MAW Communications Pictorial Description of PPL's Pole Attachment Policy

MAW Communications' Pictorial Description of PPL's Pole Attachment Policy Notes

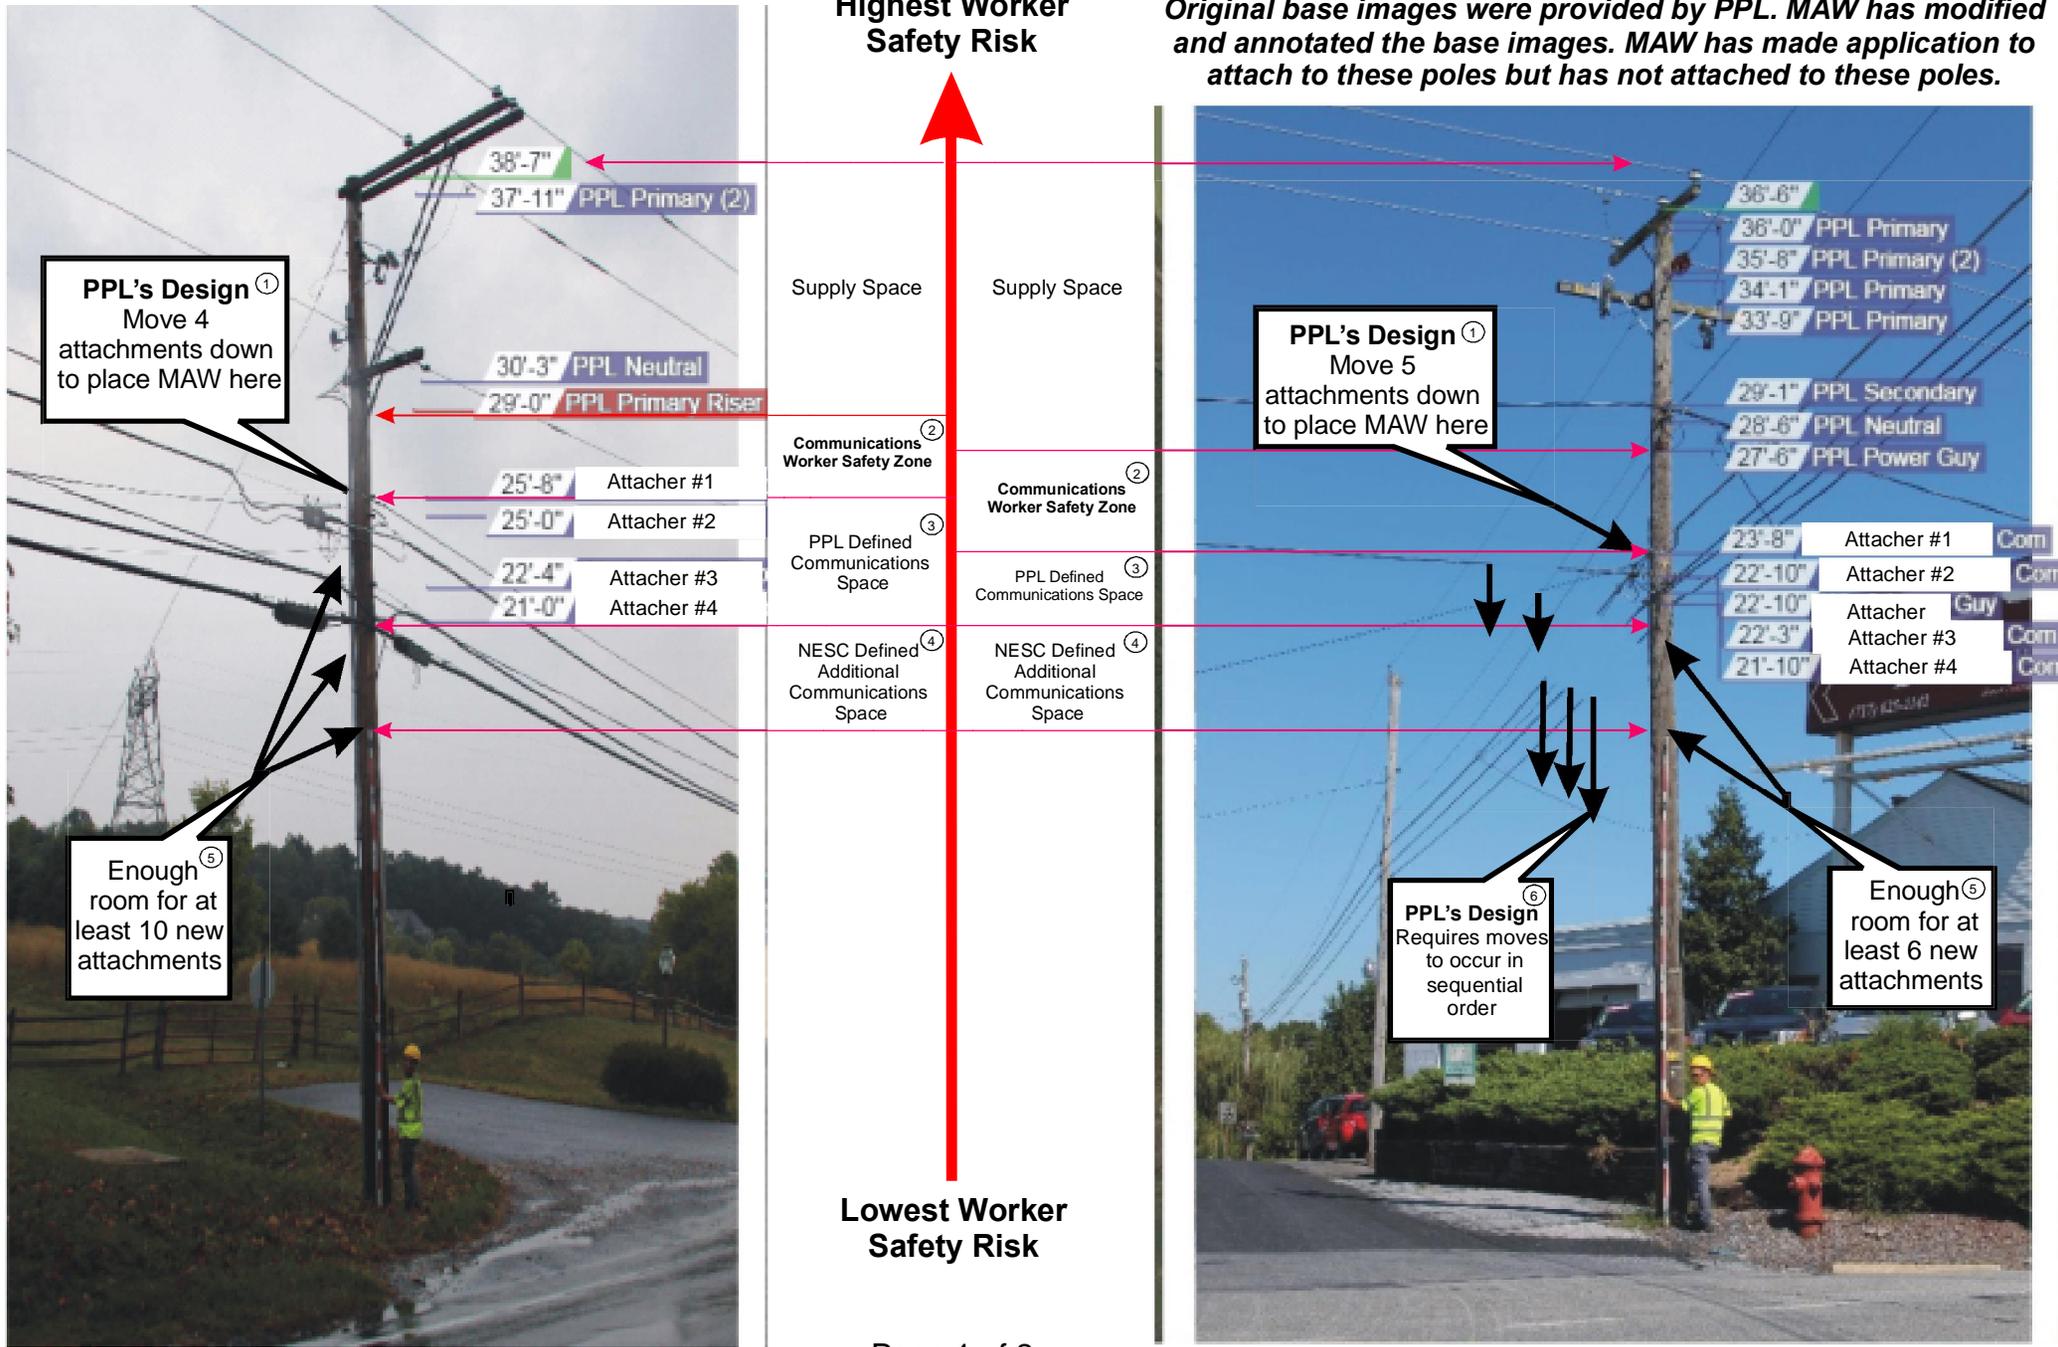
1. PPL's Attachment Policy forces the Attacher to be assigned onto the top most position of the Communications Space. All other attachments must be lowered to accommodate the new attachment. PPL does not allow MAW to perform its own network engineering per National Electrical Safety Code (NESC) public utility definitions and joint use specifications. As a result, being assigned into the topmost position creates an exponential increase in Make ready costs that increase with each new attachment. *See NESC : Rule 222, Section 2 Definitions for Joint Use, Utility, Communications Space, Supply Space; MH : Page 149, 151, 155, 169, 170, 171, 582.*

2. NESC defines this space as the safety zone for Communication Space Workers. Per NESC, except for special conditions, all attachments are prohibited in this space. By being assigned into the topmost position of the Communications Space, the Worker is exposed to higher risk being at the topmost point and therefore exposed to the highest risk to work in the Communications Space. PPL's assignment into the topmost position creates additional Worker safety risk each time a new attacher is added. PPL's design methodology is diametrically opposed to NESC engineering position assignment guidelines of the lowest voltage being the lowest Attachment. Fiber optic cables have zero volts and therefore should be the lowest Attachment on the Pole per NESC. *See NESC : Rule 220 A, Rule 235, Section 2 Definitions for Communications Space, Supply Space; MH : Page 163, 165, 167, 270, 271, 274, 275, 579, 580, 603, 604, 605, 606, 607, 608, 609, 610, 611.*

3. PPL's Attachment policy defines the bottom of the Communications Space as the point where the ILEC (Verizon, Windstream, etc.) is attached. The result is an artificially reduced Communications Space. If this space is filled, the pole must be replaced and the cost is passed onto the Attacher. According to PPL's policy, the ILEC can perform their own engineering and reduce available Communications Space, thereby limiting competitive access to the Pole by CLECs (such as MAW) by attaching higher than is required by NESC guidelines. *See NESC : Rule 232, Table-232-1; MH : Page 201, 202, 212, 219, 220, 591.*

4. In its engineering, whenever possible, MAW uses a minimum height of 18 feet of clearance for any span that will eventually cross a state road, represented here by the top of the measuring stick. (In the event that the span does not cross a state road, the NESC defines a number of other minimum height requirements.) This section represents the area between the ILEC attachment, and the actual NESC minimum height requirement, which should be available for additional communication attachments. This artificial reduction in the size of the Communications Space results in additional pole replacement costs for any new Attachments. *See NESC : Rule 232, Table-232-1; MH : Page 201, 202, 212, 219, 220, 223, 591.*

5. If MAW performs its own network engineering per NESC public utility definitions and joint use specifications, MAW would select one of the open positions on the Pole. The amount of Make Ready work is exponentially reduced and in certain instances, eliminated. PPL assignment to the topmost position and their prohibiting of the attaching utility to perform their own engineering in the Communications Space is singularly unique. *See NESC : Rule 222, Rule 232, Table-232-1, Section 2 Definitions for Joint Use, Utility, Communications Space, Supply Space; MH : Page 149, 151, 155, 169, 170, 171, 278, 285 582.*

6. The lowest attachment must move down first to make room for the second lowest attachment, and so on until the topmost position is free. Each movement has its own FCC mandated timeframes. The Attacher must wait for all iterations to complete before being allowed to attach according PPL's policy. Consequently, the time required for all Make ready work can take years to complete and grows with the number of attachers. For example, five existing attachments would require five FCC mandated timeframes to elapse before the new attacher is allowed to attach. The result is additional, needless delay that could add years to the project.

7. The position immediately above a light fixture is normally filled last. See Note – 2.
8. The ILEC is currently not attached to these poles. Consequently, PPL's Communications space agrees with NESC. However, despite the available space for many more attachments, and whenever possible, CATV cables should be placed higher than zero voltage communication cables; PPL's policy places the new attacher (MAW) at the topmost position. The result is unnecessary Make Ready and its associated costs. See Note – 2.
